Access Compliance Report Public Rights-of-Way (Curb Ramps)

Main Street: FRALEY_ST Cross Street: KATELLA_AVE Location: SW

ADA ID: RPRK210920120718 Ramp Type: Type 1 - Perpendicular Diagonal Initial Pass/Fail: Fail Overall Compliance: No Severity Score: 2

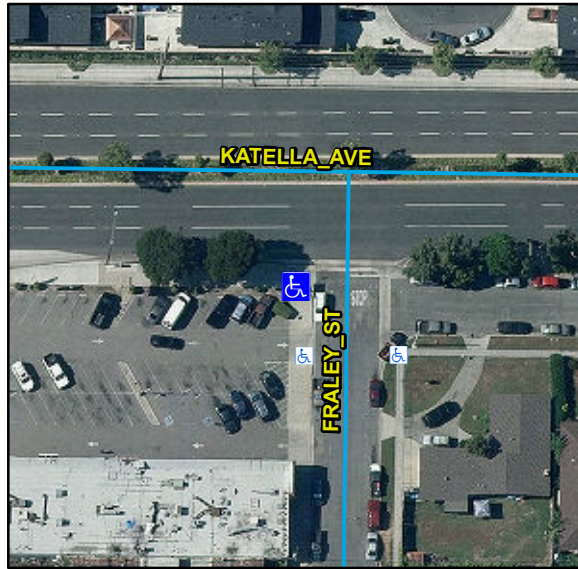
Compliance	Description	Data	Compliance	Description	Data
N/A	Ramp Length (in)	95	N/A	Flare Type LT	
Yes	Ramp Width (in)	48			N/A
Yes	Ramp Run Slope (%)	1.4	N/A	Flare Slope LT (%)	N/A
No	Ramp Cross Slope (%)	2.8	N/A	Flare Traversable LT	N/A
N/A	Landing Present	N/A	N/A	Flare Type RT	
N/A	Landing Length (in)	N/A			N/A
N/A	Landing Width (in)	N/A	N/A	Flare Slope RT (%)	N/A
N/A	Landing Run Slope (%)	N/A	N/A	Flare Traversable RT	N/A
N/A	Landing Cross Slope (%)	N/A	N/A	DWS Provided	N/A
N/A	Landing Movement Obstructed?	N/A	N/A	DWS Contrast	N/A
	Landing Movement Type	N/A	N/A	DWS Length (in)	N/A
N/A	Landing Shared	N/A	N/A	DWS Full Width	N/A
N/A	Clear Space	Yes	N/A	DWS Offset Left (in)	N/A
N/A	Clear Space To Crosswalk (in)	N/A	N/A	DWS Offset Right (in)	N/A
N/A	Marked Crosswalk 1	No	N/A	Marked Crosswalk 2	No
	Crossing 1 Direction	E		Crossing 2 Direction	N
	Marked Crosswalk 1 Width (in)	N/A		Marked Crosswalk 2 Width (in)	N/A

N/A	Ramp Inside Crosswalk 1	N/A	Yes	Ramp Inside Crosswalk 2	N/A
	Crossing 1 Slope (%)	1.1		Crossing 2 Slope (%)	10.1
	Crossing 1 Cross Slope (%)	1.6		Crossing 2 Cross Slope (%)	0.2
N/A	Gutter Ponding	N/A	No	Curb Slope	6.3
Yes	Gutter Lip Height (in)	0		Road Run Slope (%)	2.7
N/A	Gutter Run Slope (%)	N/A		Road Cross Slope (%)	1.8
N/A	Gutter Cross Slope (%)	N/A			
Yes	Overall Surface Condition: Acceptable		Yes	Perp Joint Present	Yes
	Cross Gutter Present?	Yes		Spandrel Present?	Yes
	Replace Cross Gutter?	No		Replace Spandrel?	No

Remove & Replace Curb Ramp With Two New Directional Ramps or Equivalent.
